REV		DATE	DESCRIPTION
A	07/28/2022	RFI	FOR LEVEL 2 BEAM LOCATIONS

JOB NAME: OLD FIREHOUSE

REVISIONS		
REV.	DATE	DESCRIPTION
A	07/28/2022	RFI FOR LEVEL 2 COLUMN LOCATIONS

REV.		DATE	DESCRIPTION
A		07/29/2022	RFI FOR LEVEL 3 COLUMN LOCATIONS

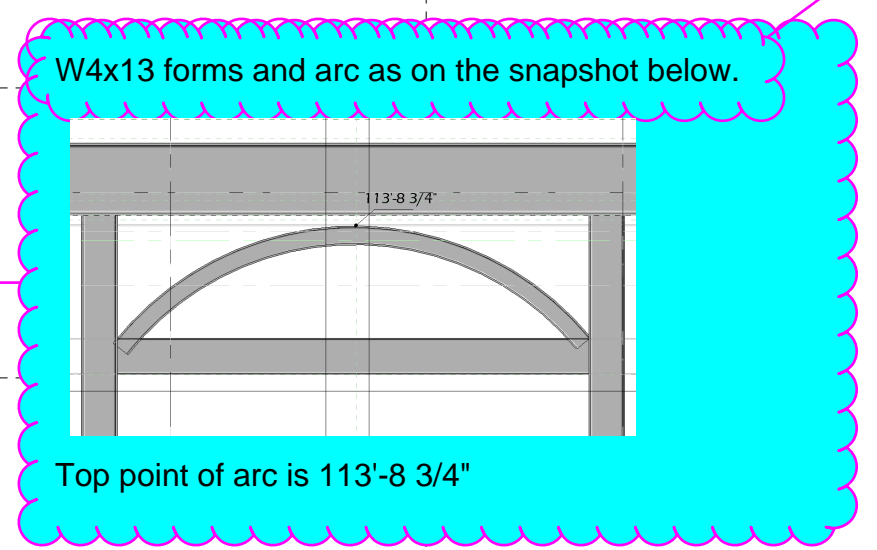
Joel, we don't have connection identified on 3/S3.6 - just an embed and W8x18 shown. We assume the idea was to weld W8s to embeds. Please advise on the welding sizes.

Length of the channel should be calculated as the width of the opening plus 16" MIN EA side of the opening. B.O.S. should be equal to the top of existing opening. See detail 16/S3.5

Top of openings is 111'-0" With 12" high HSS, 112'-0" is correct.

LEVEL 2 BEAM FRAMING LOCATION PLAN
NOTES:
 1. ALL DIMENSIONS ARE TO CENTER OF BEAMS AND GRIDS.
 2. ALL MARK DIRECTIONS ARE SET TO PLAN NORTH.
 3. B.B.P. = BOTTOM OF BASE PLATE.
 4. T.O.S. = TOP OF STEEL.

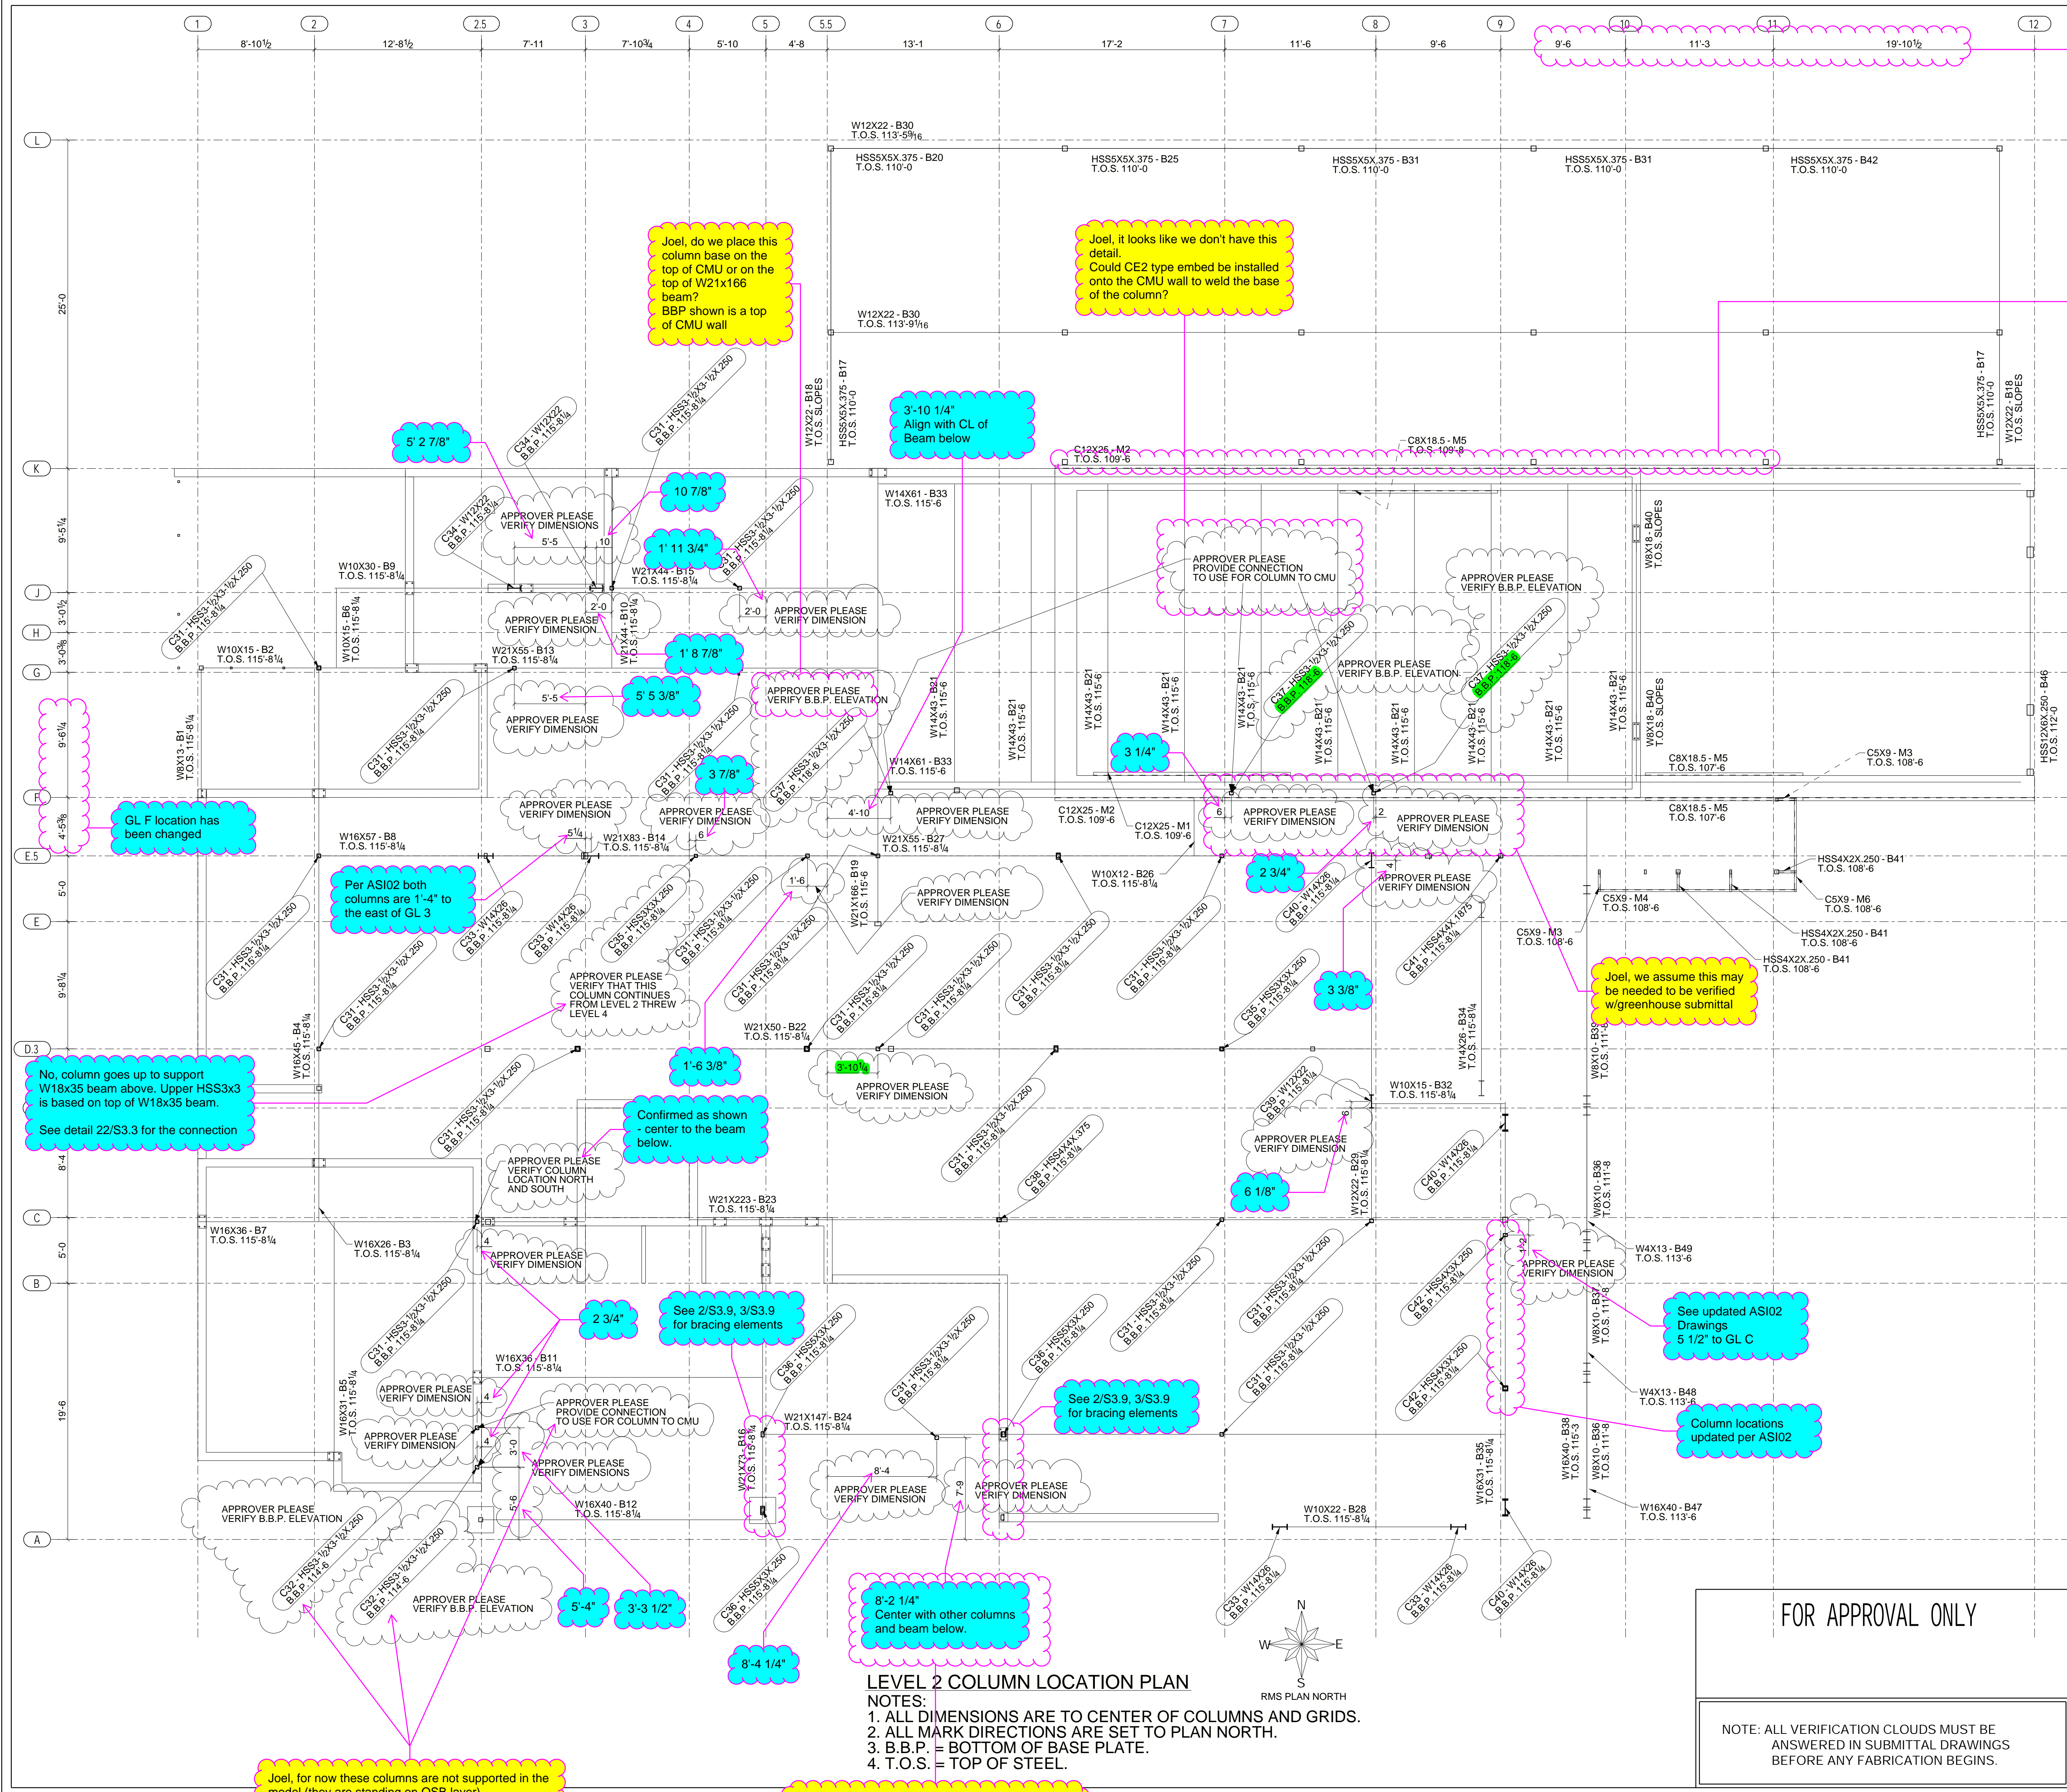
Joel, we don't see these arcs in the latest Arch model. Have they been removed?

Joel, do we place this column base on the top of CMU or on the top of W21x166 beam? BBP shown is a top of CMU wall

Joel, it looks like we don't have this detail. Could CE2 type embed be installed onto the CMU wall to weld the base of the column?

Joel, for now these columns are not supported in the model (they are standing on OSB layer).

Joel this column was off the center of the beam below. Looks like it was made to align this column with the

Adjust GL12 location per the recent changes and maintain 1'-0" offset as shown.

See Updated GL Dimensions per latest Arch

4-HSS columns here have been removed per ASI02 - existing wall changes. Channel to be bolted to the bond beam over the existing wall.

Confirmed as shown - center to the beam below.

See 2/S3.9, 3/S3.9 for bracing elements

See updated ASI02 Drawings 5 1/2" to GL C

Column locations updated per ASI02

8'-2 1/4" Center with other columns and beam below.
